September 23, 2003

APPLICANT: Omaha Public Power District

FACILITY: Fort Calhoun Station, Unit 1

SUBJECT: SUMMARY OF MEETING WITH OMAHA PUBLIC POWER DISTRICT (OPPD)  
TO DISCUSS DRAFT RESPONSES TO REQUESTS FOR ADDITIONAL  
INFORMATION (RAIs) FOR THE RENEWAL OF THE OPERATING LICENSE  
FOR FORT CALHOUN STATION, UNIT 1 (FCS)

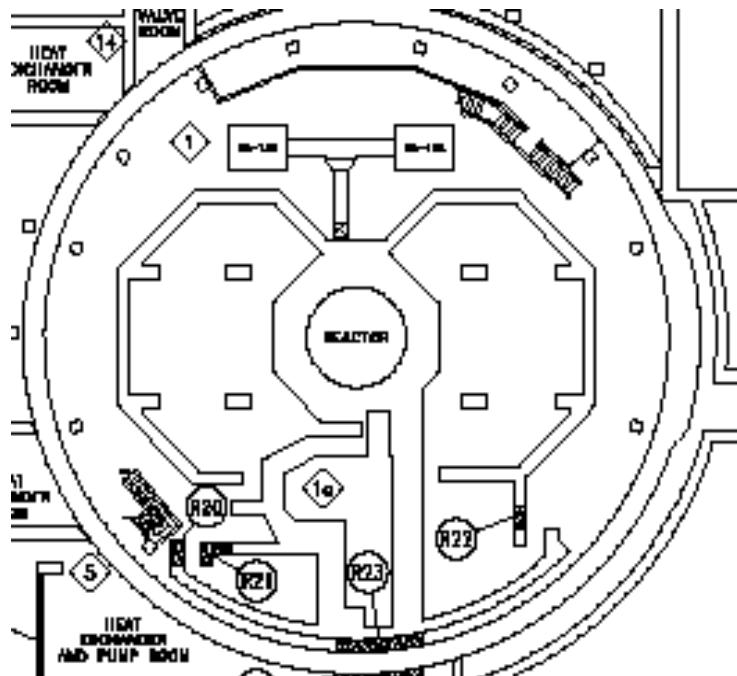
aggressive, provide water chemistry data, such as pH, chlorides, and sulfates. In order for the staff to assess the variability of the below-grade environment, please provide the above data since initial plant construction.

NUREG-1557 indicates aggressive environments for concrete have a pH less than 5.5, sulfates greater than 1500 ppm, and chlorides greater than 500 ppm

To verify the river water and groundwater chemistry had not significantly changed over 20-30 years, a chemical analysis was performed in June 2000. Those test results indicated groundwater pH was 7.48, chlorides were 8.0 ppm, and sulfates were 79.0 ppm; river water pH was 8.39, chlorides were 14.0 ppm, and sulfates were 229 ppm.
